AP 101B-1309-2  
Leaflet No. J.1

HUNTER G.A. MK. 11, P.R. MK 11 - AIRCRAFT - Wing - To introduce  
Socket Part No. B. 250315 in lieu and by conversion of B.198325  
(26FX/12878).

(Mod. No. Hunter 1334)

Fuselage - Improved Fatigue Meter Access AP101B-1309-2  
Leaflet No J2

DRG. NO. AP101B-1309-2/J1/68

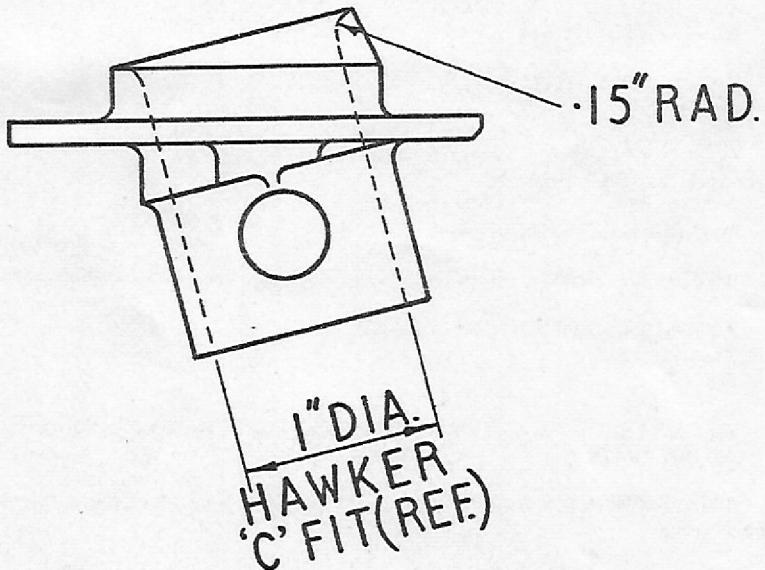
HOLE IN FITTING TO BE  
CHAMFERED AS SHOWN.  
IT IS IMPORTANT THAT  
THIS RADIUS IS STRICTLY  
ADHERED TO AND THAT  
THE SURFACE IS FREE  
FROM ALL TOOL MARKS.

RE-PART N° SOCKET B.250315

- (1) With wings removed, at root end of wings (Port and starboard) adjacent to leading edge of nose rib 'A', locate socket, Part No. B.198325.
- (2) Using radius cutter tool, Part No. T.609117JD, form .15 in. radius as shown in the Drawing.
- (3) Remove all tool marks from socket
- (4) Re-part number modified socket as B.250315.
